CITY OF CODY  
PLANNING, ZONING AND ADJUSTMENT BOARD  
TUESDAY MARCH 29, 2022  
CITY HALL COUNCIL CHAMBERS @ 12:00 NOON

<b>MEETING DATE:</b>	MARCH 29, 2022	<b>TYPE OF ACTION NEEDED</b>	
<b>AGENDA ITEM:</b>		P&Z BOARD APPROVAL:	X
<b>SUBJECT:</b>	REQUEST FOR A 6-FOOT FENCE IN THE FRONT YARD OF 3502 APACHE ROAD.	RECOMMENDATION TO COUNCIL:	
<b>PREPARED BY:</b>	TODD STOWELL, CITY PLANNER	DISCUSSION ONLY:

<b>MEETING DATE:</b>	MARCH 29, 2022	<b>TYPE OF ACTION NEEDED</b>	
<b>AGENDA ITEM:</b>		P&Z BOARD APPROVAL:	
<b>SUBJECT:</b>	PRELIMINARY PLAT FOR THE DANSIE MINOR SUBDIVISION, A 3-LOT MINOR SUBDIVISION. SUB 2022-01	RECOMMENDATION TO COUNCIL:	X
<b>PREPARED BY:</b>	TODD STOWELL, CITY PLANNER	DISCUSSION ONLY:

<b>MEETING DATE:</b>	MARCH 29, 2022	<b>TYPE OF ACTION NEEDED</b>	
<b>AGENDA ITEM:</b>		P&Z BOARD APPROVAL:	
<b>SUBJECT:</b>	PRELIMINARY PLAT OF THE WEST AVENUE DUPLEXES SUBDIVISION— AN 8-LOT SUBDIVISION. SUB 021-08	RECOMMENDATION TO COUNCIL:	X
<b>PREPARED BY:</b>	TODD STOWELL, CITY PLANNER	DISCUSSION ONLY:

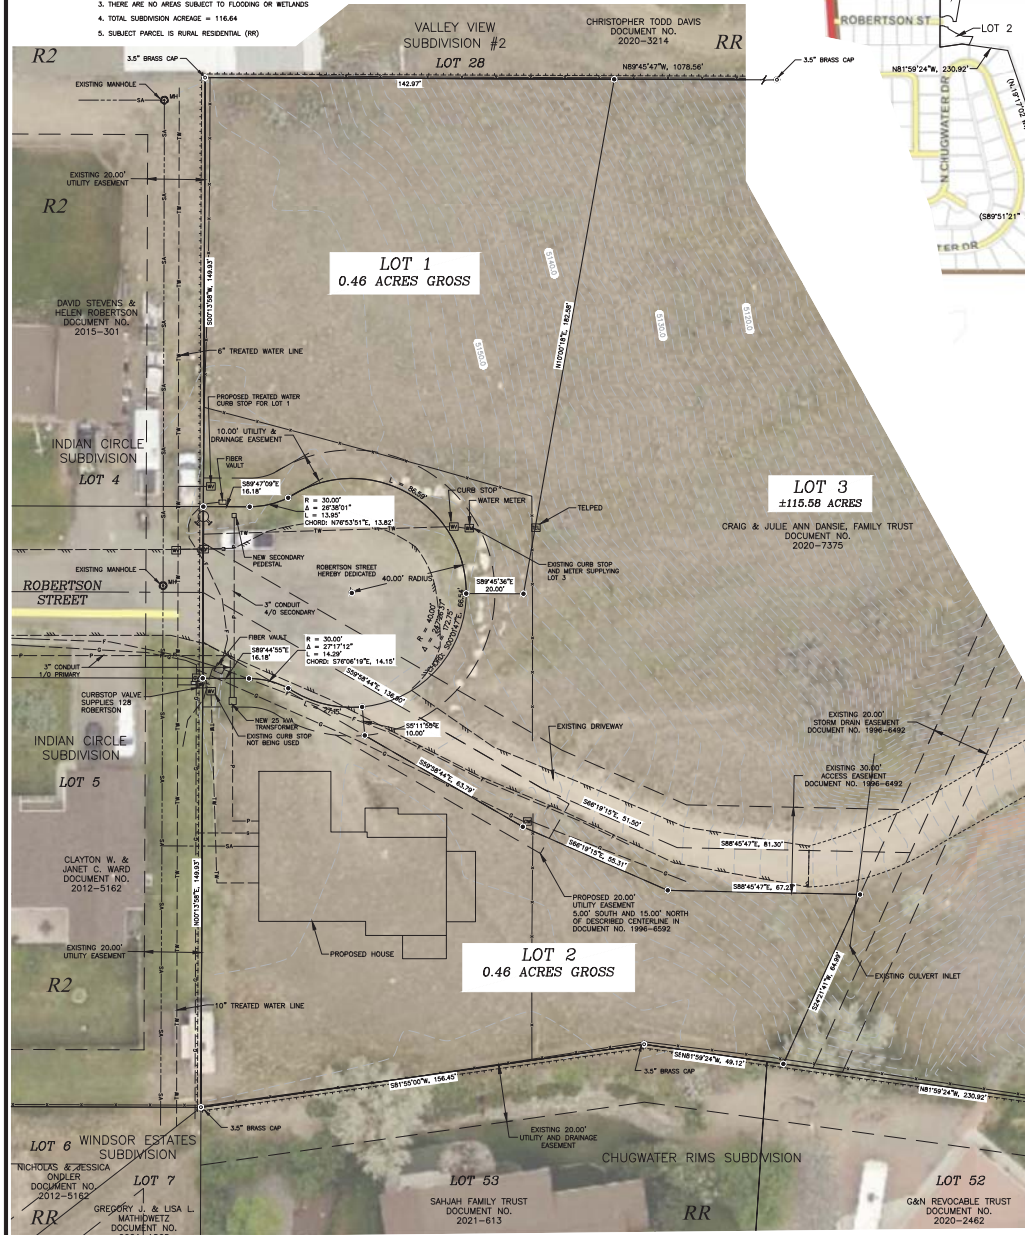
Comment- No new public streets or alleys are required. The existing cul-de-sac at the end of Robertson Street will need to be improved to City standards and is aligned with the existing street.

Comments- Robertson Street is identified as a "rural" street by the Master Street Plan. This standard refers to a 32-foot-wide asphalt road with no curb, gutter, or sidewalk. The physical width of Robertson Street is 24 feet with an asphalt surface. A swale is to be maintained along the edge of the rural street section, for stormwater purposes.

Comment: As noted previously, the applicable street standard is a rural standard, with no curb, gutter or sidewalk. A separated pathway is identified in the rural street standard, but a variance is requested. The cul-de-sac is at the end of a fully developed subdivision with no sidewalk and no potential for further subdivision. Also, there are no building sites off the end of the cul-de-sac. So, the likelihood of pedestrian traffic around the cul-de-sac is practically non-existent. Therefore, a variance to the pathway requirement seems reasonable due to these characteristics.

Comment: Enlargement of the cul-de-sac will need to be designed and constructed per City standards. Simple grading and pavement section plans will need to be submitted with the final plat.

Comment: Lots 1 and 2 will connect to City sewer, as shown. The house on Lot 3 is served by an existing septic system, which is allowed to remain. If the septic system on Lot 3 ever fails, analysis would be conducted to determine if connection to City sewer would occur. (At over 1,100 feet away, it is unlikely.)

Comment: Will be met as proposed. Lots 2 and 3 already have curb stops installed for City water. Lot 1 will connect to the water main near its southwest corner, as shown.

Comment: Met. A hydrant is at the southwest corner of Lot 1.

1. Provide the final plat documents in accordance with the subdivision ordinance.
2. The final plat must include the property line and property corner information for Lot 3, as all of it is within the subdivision. (Clean up the middle map.)

3. With the final plat application, provide grading and pavement detail plans of the cul-de-sac expansion for review and approval. Grading of a swale around appropriate portions of the perimeter (north side) is to be included. Construction of the expansion will need to occur prior to issuance of building permits on Lots 1 and 2; provided, a building permit may be issued if a financial security (e.g. letter of credit, performance bond, or cash deposit) is provided to the City to ensure completion prior to issuance of a certificate of occupancy.

7. Provide an easement for the water line that runs from the water meter on Lot 1 to Lot 3, which easement is for the benefit of Lot 3.

PRELIMINARY PLAT  
SHEET 1

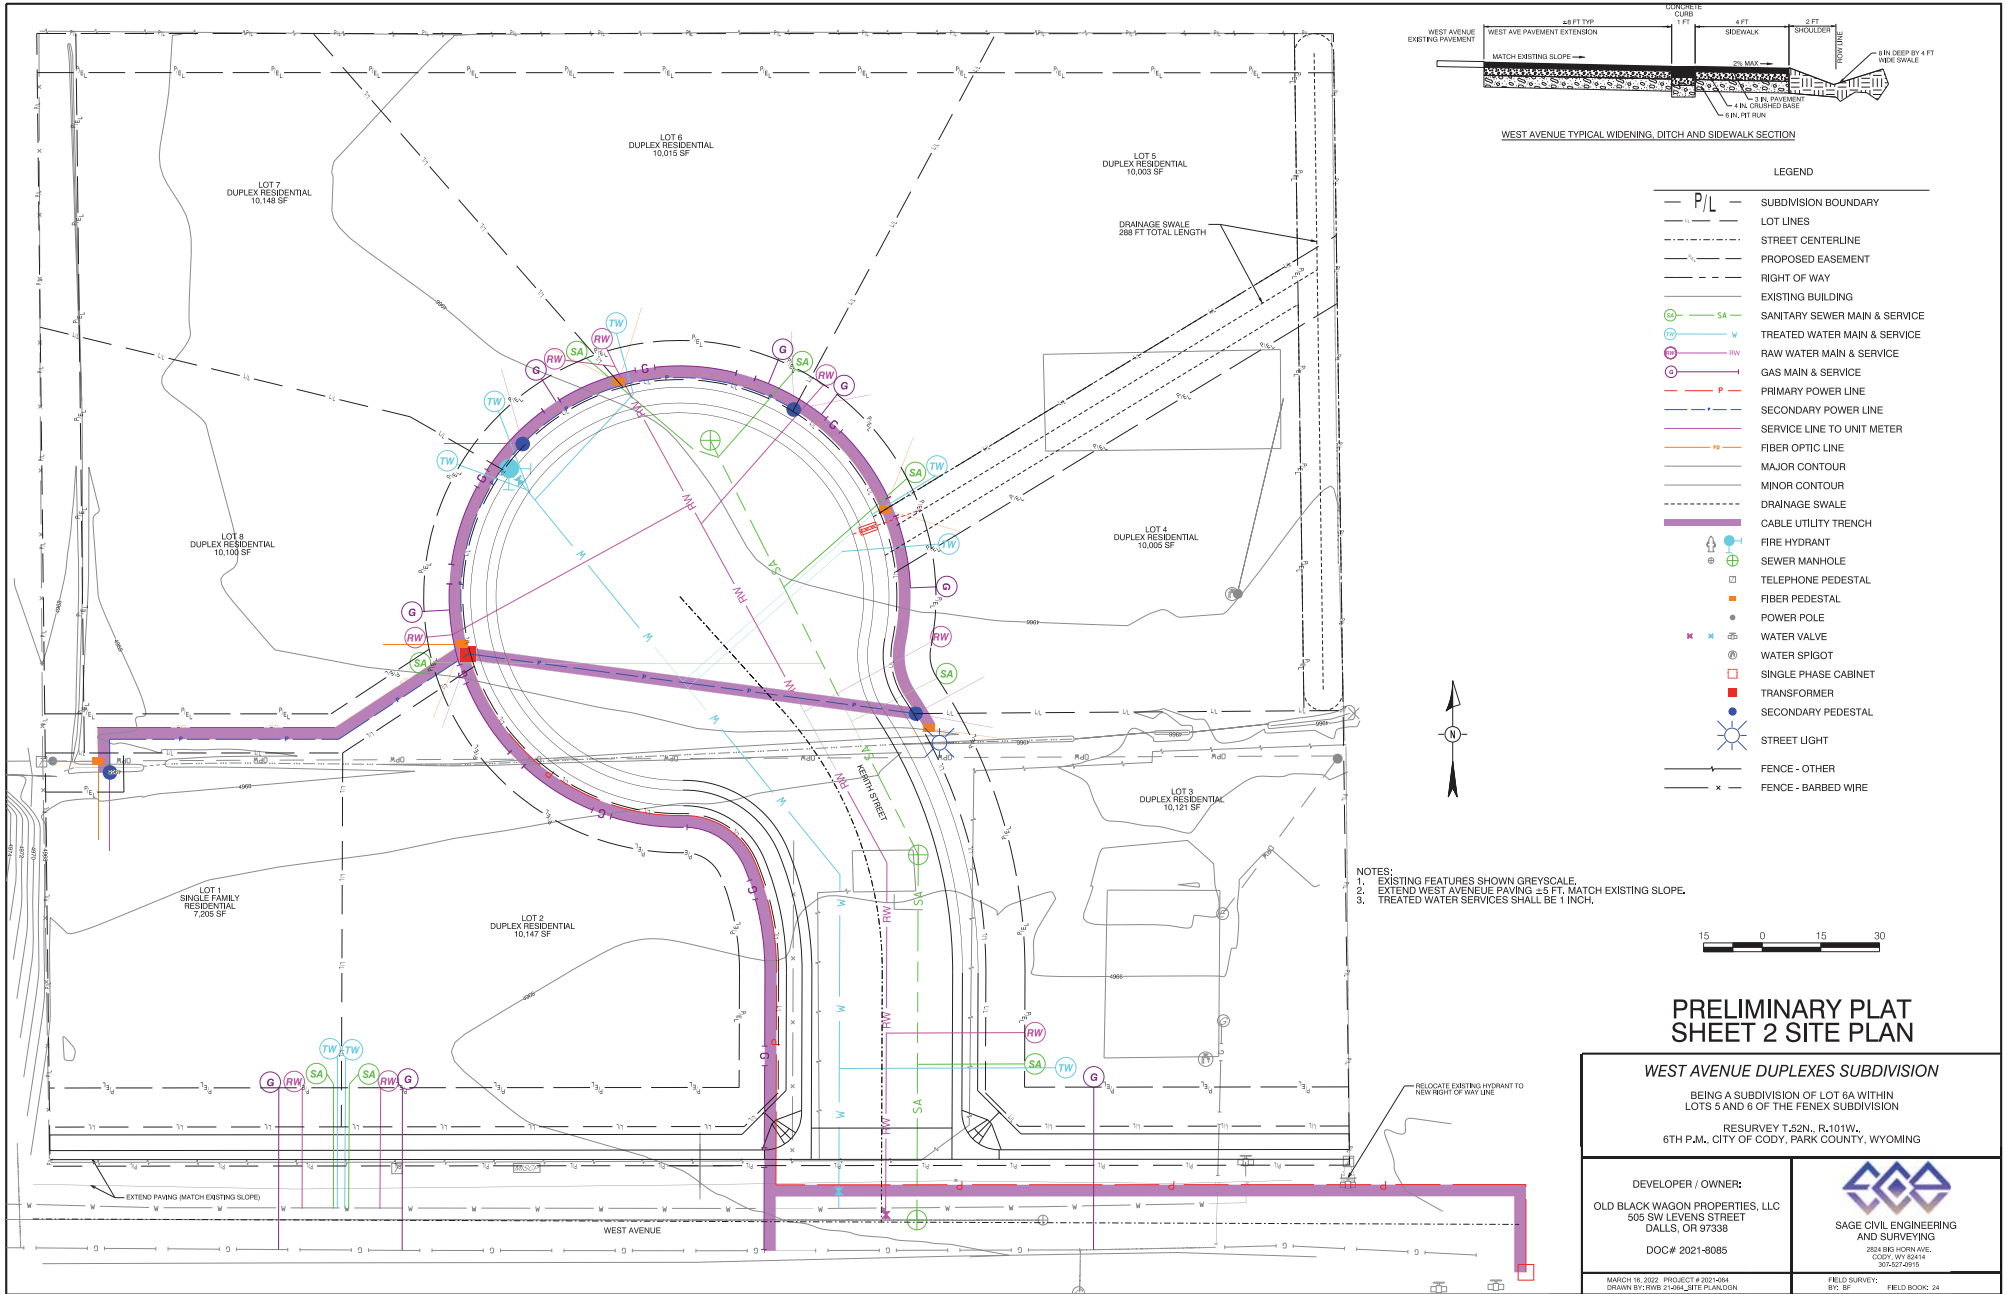
Comment: No interior streets through this property are identified in the master street plan. West Avenue only has 30 feet of right-of-way. The plat includes dedication of an additional 10 feet of right-of-way plus another 10 feet of utility and drainage easement, as requested. This meets the requirement.

Comment: The subdivision ordinance has not been updated to reflect the residential street profile of the street master plan, so a variance is requested to the 60-foot right-of-way width shown in the table. The proposed interior street would have a 53-foot-wide right-of-way as shown in the street master plan, plus 10-foot utility easements to each side, which is adequate to accommodate the street design. The proposal also includes additional right-of-way for West Avenue based on the master plan street profile. Grade requirements will be met.

Comment: The cross section shown on Sheet 2 of the preliminary plat shows an 8-foot +/- extension of asphalt for West Avenue in the cross section, and a 1-foot ribbon curb instead of the typical 2 ½ foot side curb and gutter section. A 4-foot sidewalk, rather than the 5-foot-wide standard is shown. To clarify, the dimension of asphalt from the centerline of West Avenue to the concrete ribbon curb needs to be 18 feet to provide for both the travel lane and parking strip. In addition, the edge of the street will need to be cut to provide a clean edge to match the new asphalt to the old asphalt. The plans should clearly note this. A 4-foot-wide sidewalk will be accepted by staff, as the 1-foot ribbon curb should also contribute to the walking surface.

- f. Clarify the West Avenue construction detail—18' from centerline to ribbon curb, and saw cut existing asphalt to provide clean edge.
  - g. Shift the infiltration trench to the north side of the drainage easement between Lots 4 and 5.

- f. Clarify the West Avenue detail—18' from centerline to ribbon curb, and saw cut existing asphalt to provide clean edge.
  - g. Shift the infiltration trench to the north side of the drainage easement between Lots 4 and 5.

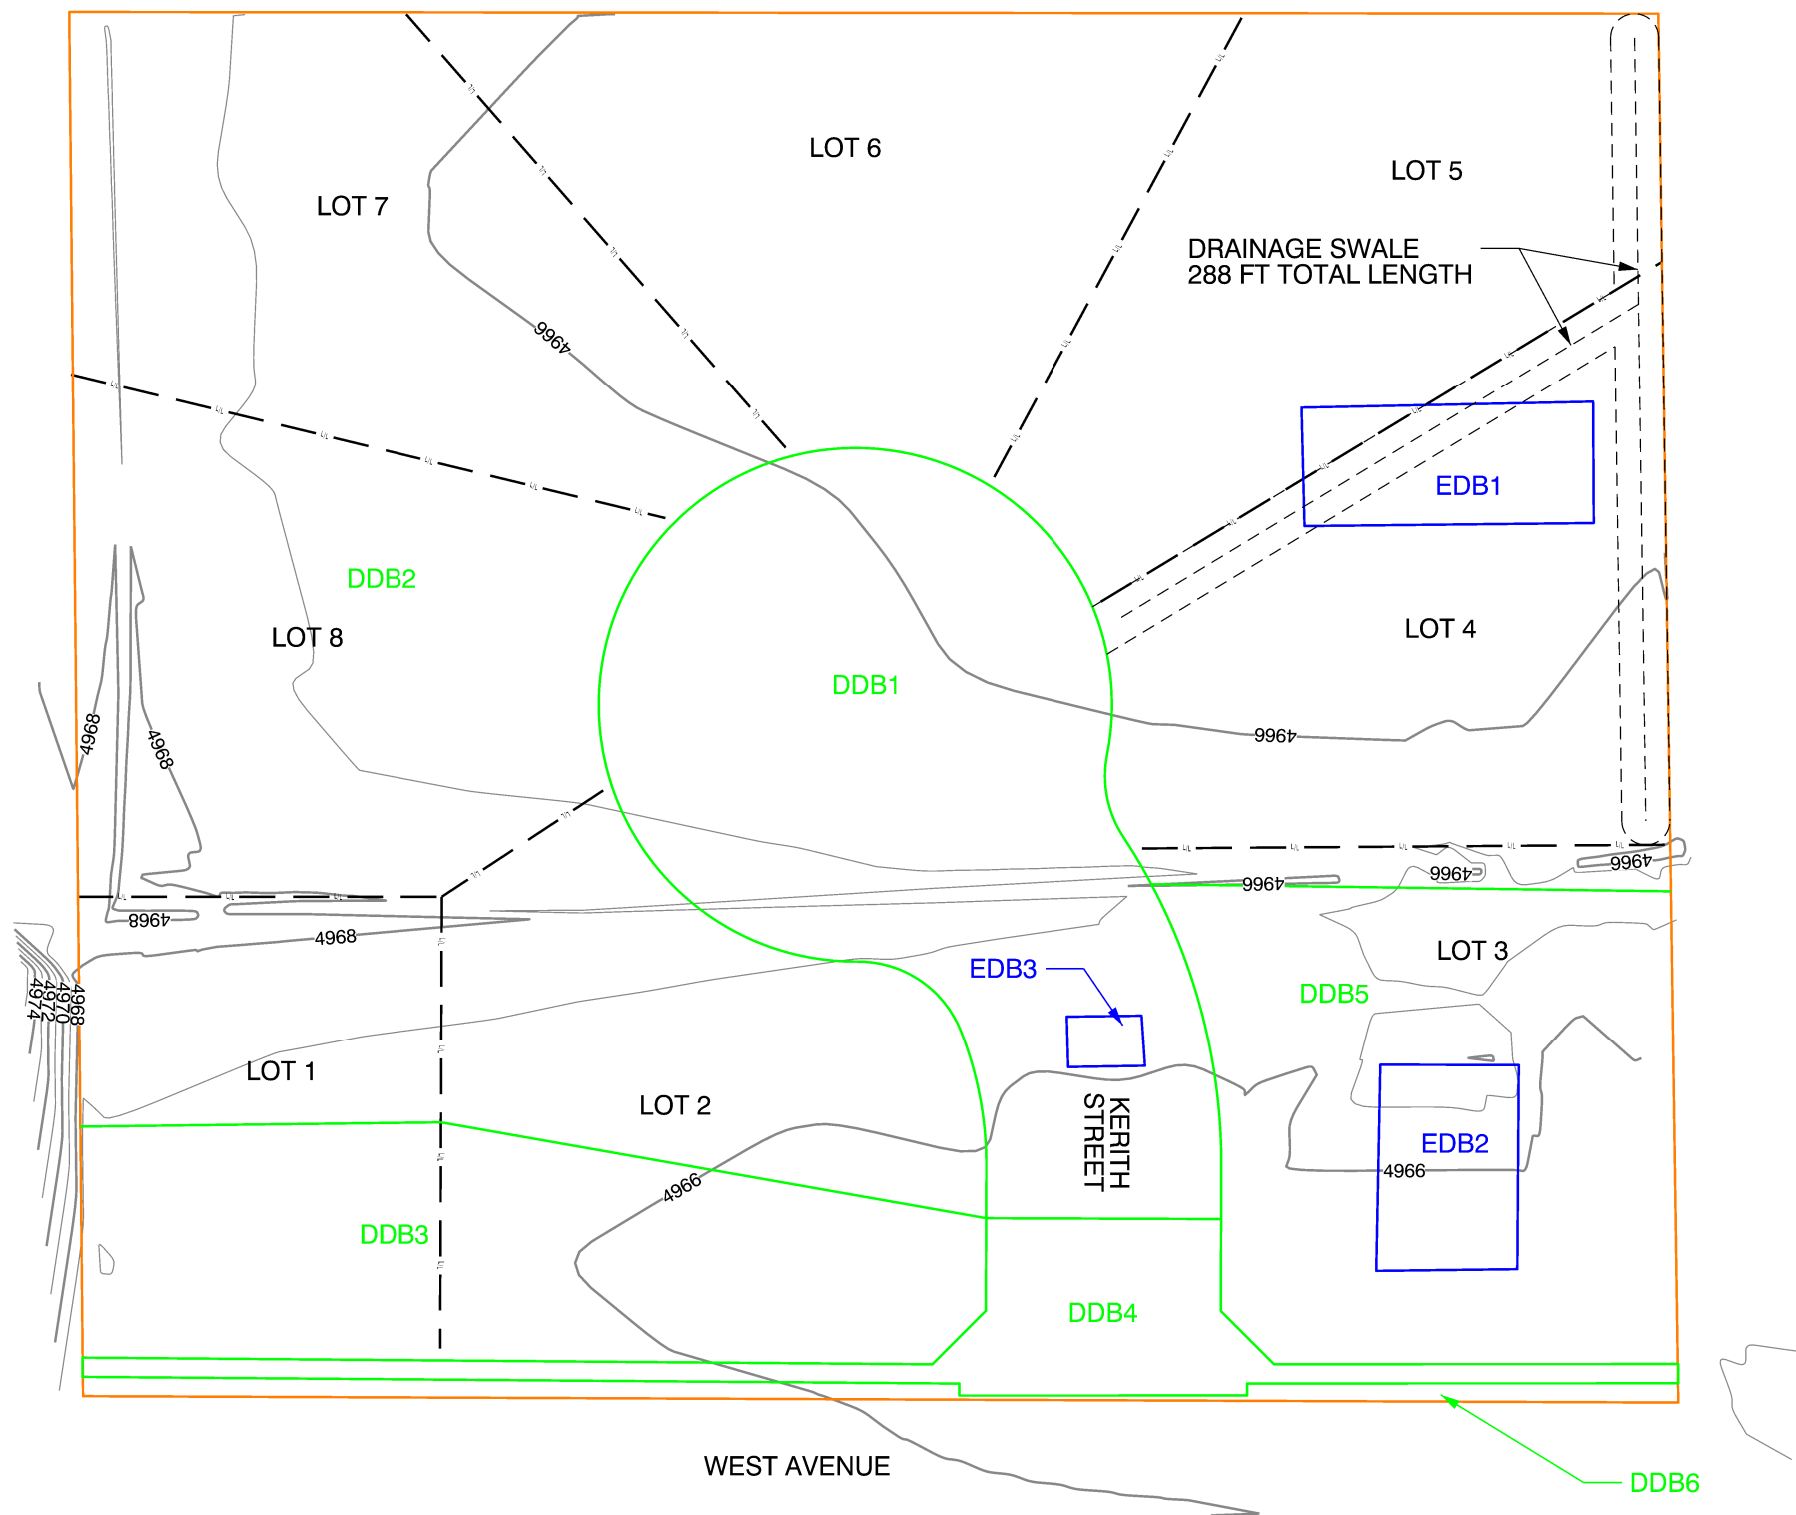
Comment: A drainage plan has been developed and is attached. It involves grading the road to have storm water run to the east side of the cul-de-sac, allowing the storm water to pass through a curb cut and into an infiltration trench that runs along the common boundary of Lots 4 and 5, and to the back of the lots. The plan meets the capacity requirements for the subdivision. It is also noted that the stormwater from West Avenue will be allowed to flow into the drainage easement along the edge of the street which will further reduce runoff potential to neighboring properties.

There is some concern that the proximity of the infiltration trench to basements or crawl spaces on Lots 4 and 5 could cause dampness in those areas. The engineer widened the drainage easement from 10 feet to 15 feet to force more separation in response to the concern. With the wider easement, any foundation on Lot 4 would be at least 6 feet from the bottom of the infiltration trench, and on Lot 5 it would be at least 11 feet, based on a 5-foot setback on Lot 5 and a 0' setback from the edge of the easement on Lot 4, if the trench is centered in the easement. Off-setting the trench to the north side of the drainage easement to even out the separation is recommended and would provide about 8 feet of separation to each side.
